MEMORANDUM

SUBJECT: Site Plan Approval – 1067 Marble Street, VL-1 Marble Street and VL-8 Water Street

DATE: November 30, 2023

1067 MARBLE STREET, WATERTOWN NY, 13601
 CITY OF WATERTOWN, JEFFERSON COUNTY, STATE OF NEW YORK
 DATED: NOVEMBER 14, 2023
SITE PLAN REVIEW

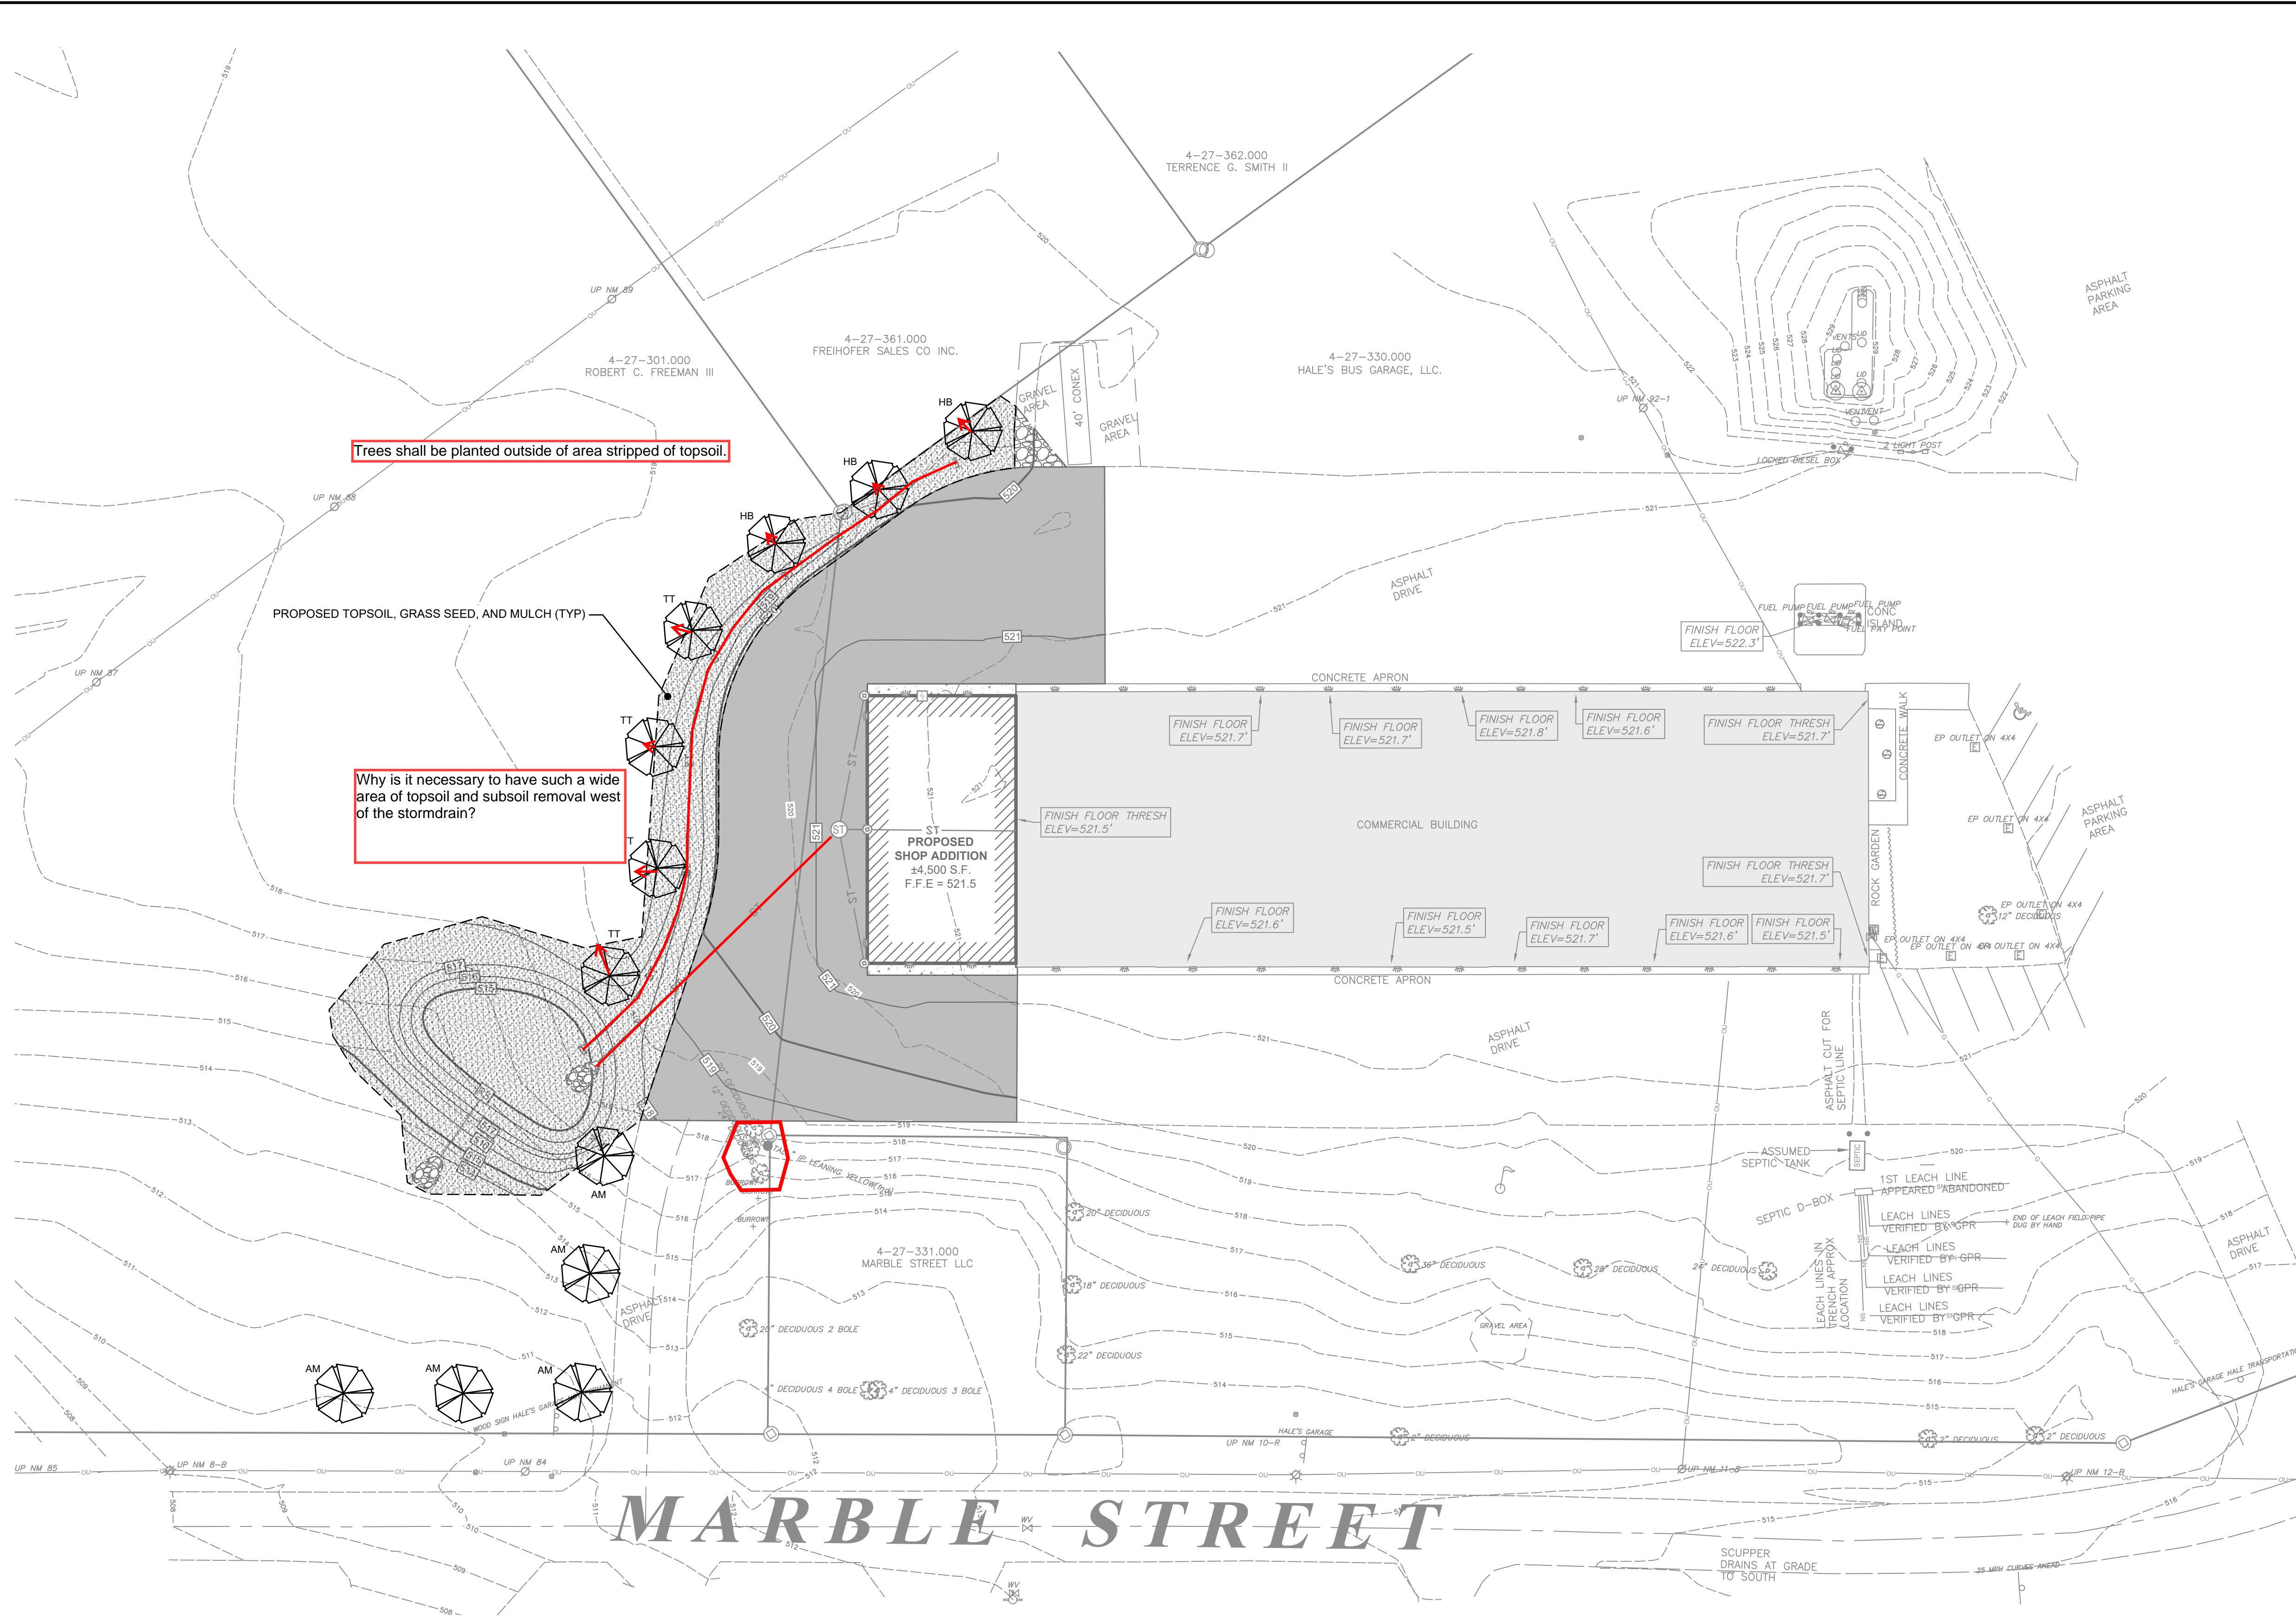
Currently, the applicant only proposes three different tree species on the Landscaping Plan; *Acer rubrum* (red maple), *Celtis occidentalis* (hackberry), and *Liriodendron tulipifera* (tulip tree). The applicant shall work with Staff to select four (4) additional site-appropriate tree species to diversify the planting schedule as well as selecting the most optimal locations for each species.

Although Red Maple and Hackberry can tolerate varying degrees of soil compaction, Tuliptrees do not tolerate compacted soils well. In the submitted Landscaping Plan, the applicant identifies a Red Maple and Tuliptree immediately and adjacent to the retention pond. Although Red Maple generally displays a moderate tolerance to soil compaction, the applicant currently anticipates compaction levels up to or exceeding 90 percent for areas 25-to-35 feet west of the paved asphalt parking. 90 percent compaction is not suitable for planting trees. Although that level of compaction may be necessary to secure underground structures and to achieve proper grading, trees should be planted in areas that receive a maximum compaction rate of 80-to-85 percent. Therefore, Staff does not recommend planting trees within the limits of disturbance. Trees should be planted west of the silt fencing and outside all disturbed areas as shown on the proposed plans.

7. The applicant shall diversify the tree species in the planting schedule to a minimum of seven (7) distinct species so that no individual species makes up more than 15 percent of the planting schedule and work with Staff to identify and confirm appropriate species and locations.

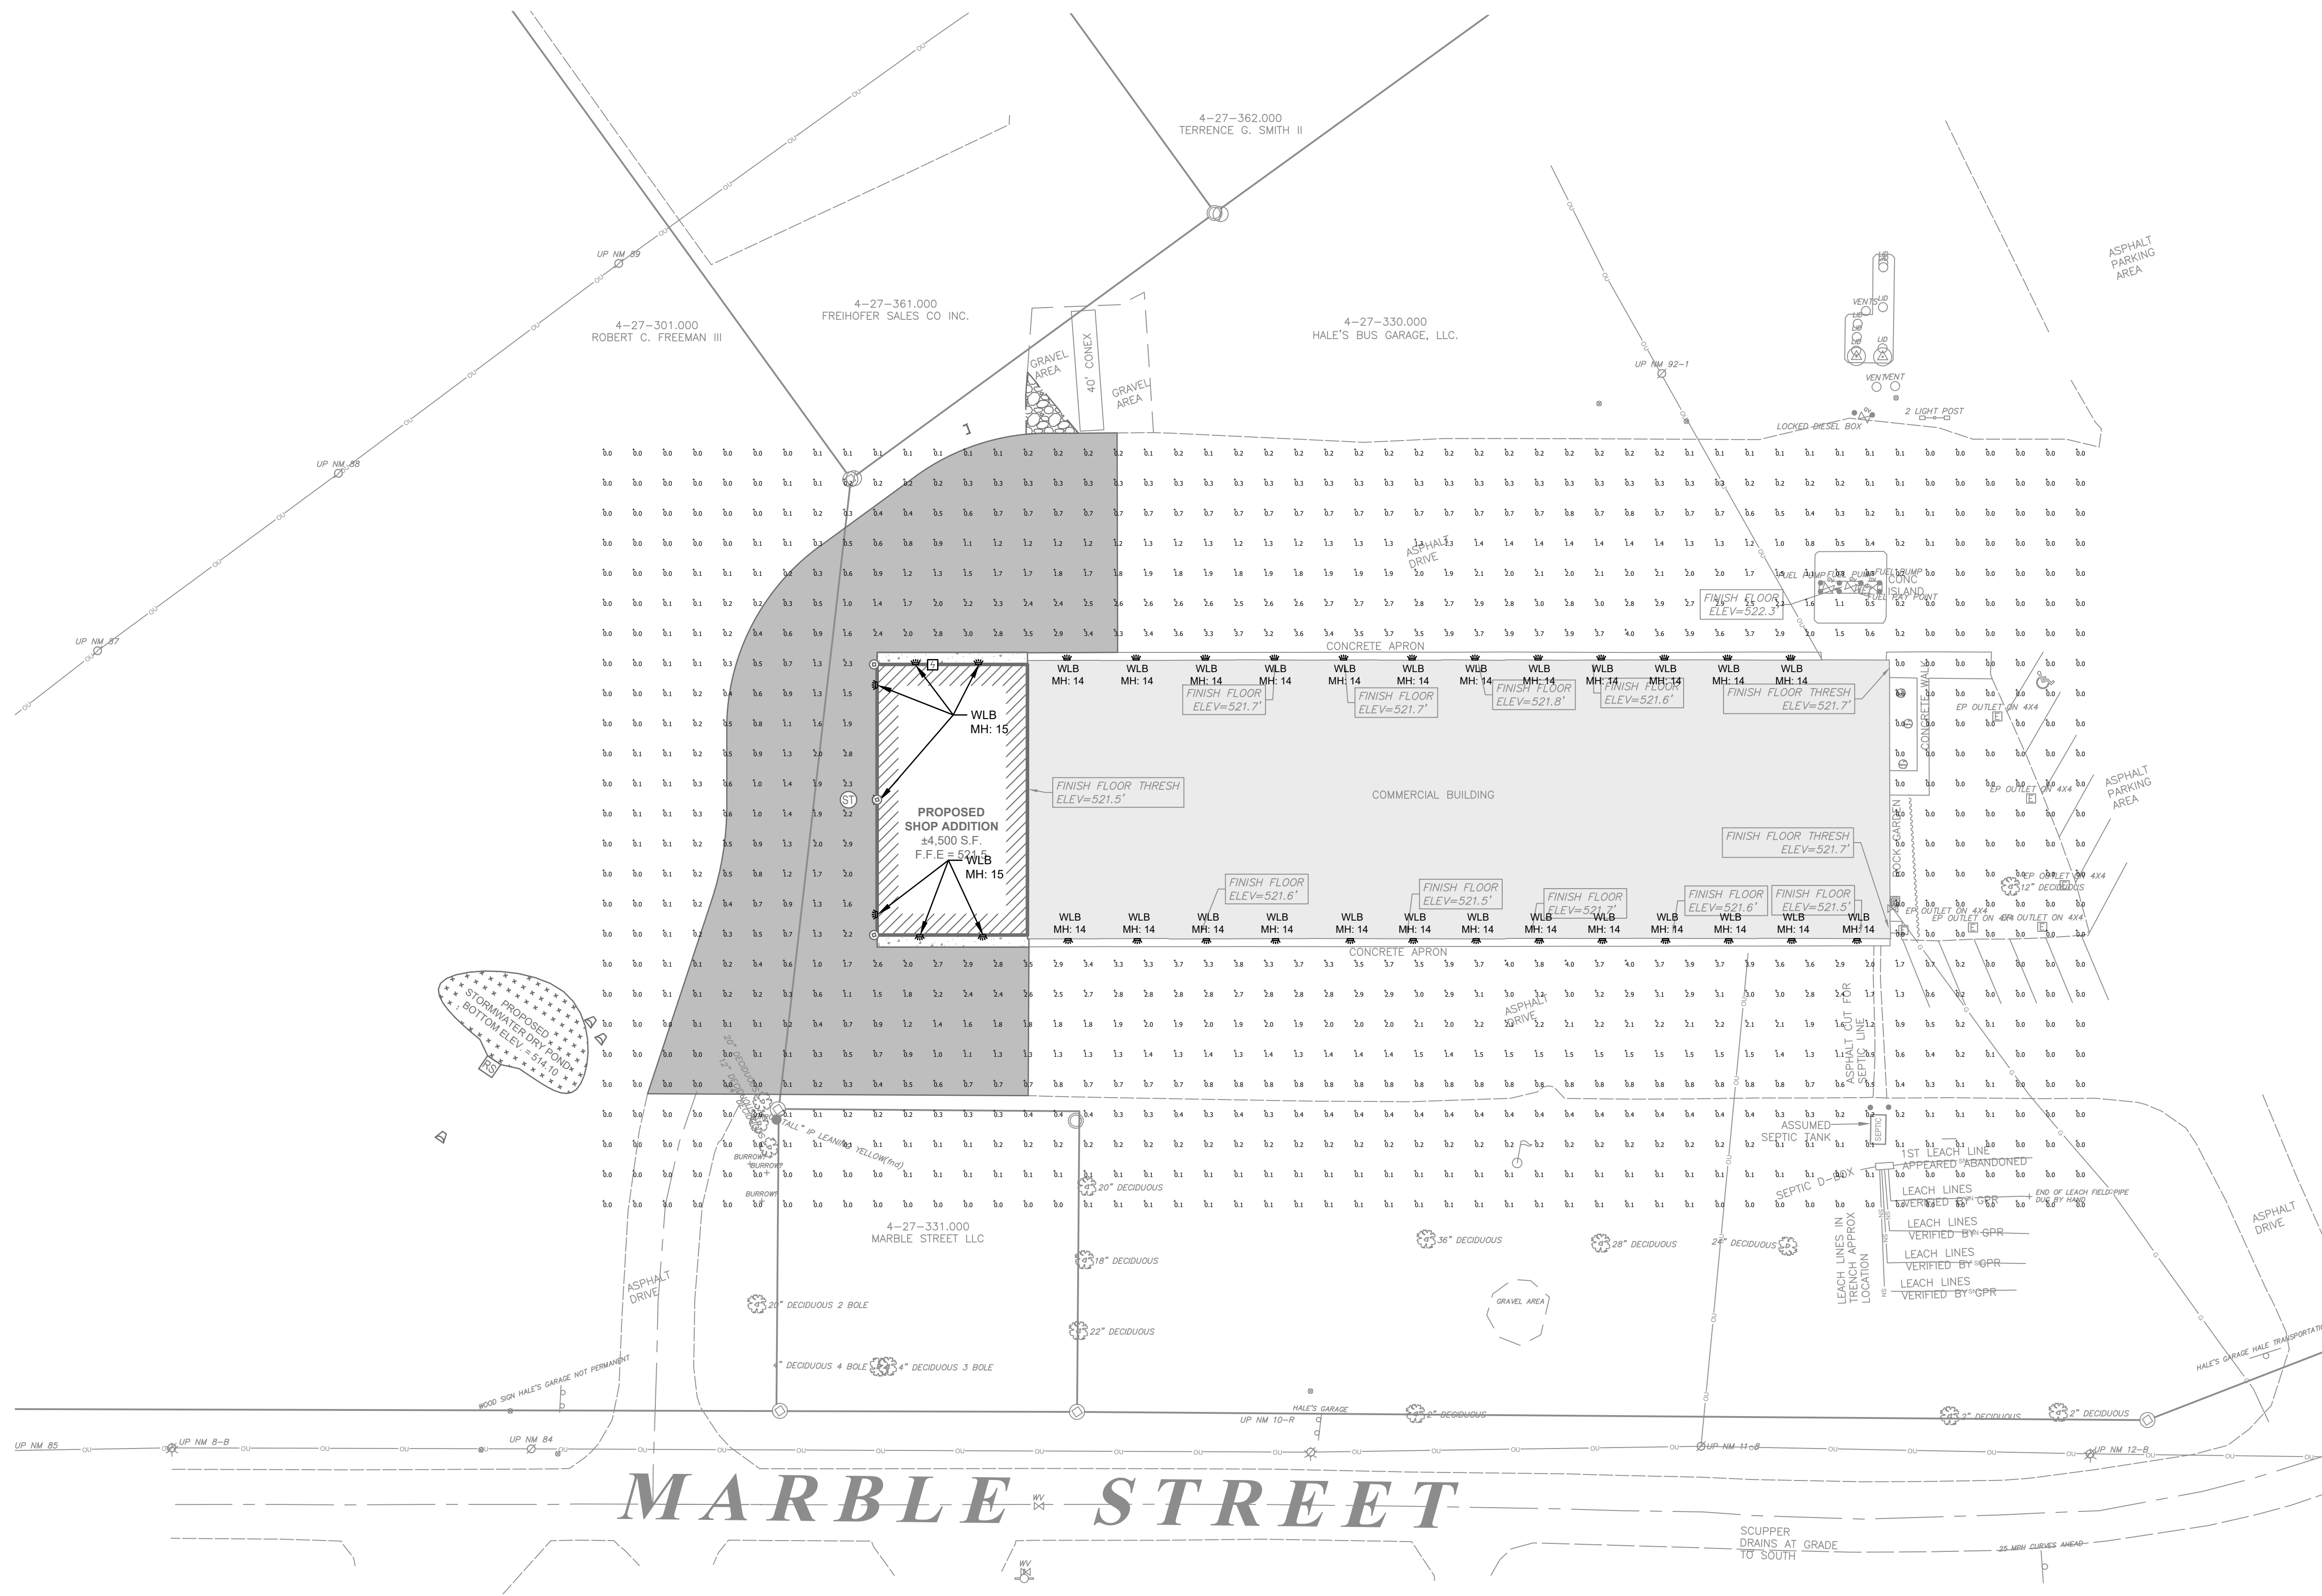
Lighting: The applicant submitted a Photometric Plan. Section 310-84 (C)(2) of the Zoning Ordinance requires that light trespass shall not exceed 0.5 footcandles at the property line. The Photometric Plan depicts up to 2.0 footcandles of spillage across the western property line onto VL-8 Water Street. This will not be an issue if the applicant chooses to assemble the properties after closing on VL-8. However, this will become an issue if they remain separate. The applicant shall be prepared to discuss the property owner’s intentions for parcel assemblage and the implications of light spillage if the lines remain where they are. The Planning Commission is not able to approve a Site Plan that will result in permanent illegal light spillage.
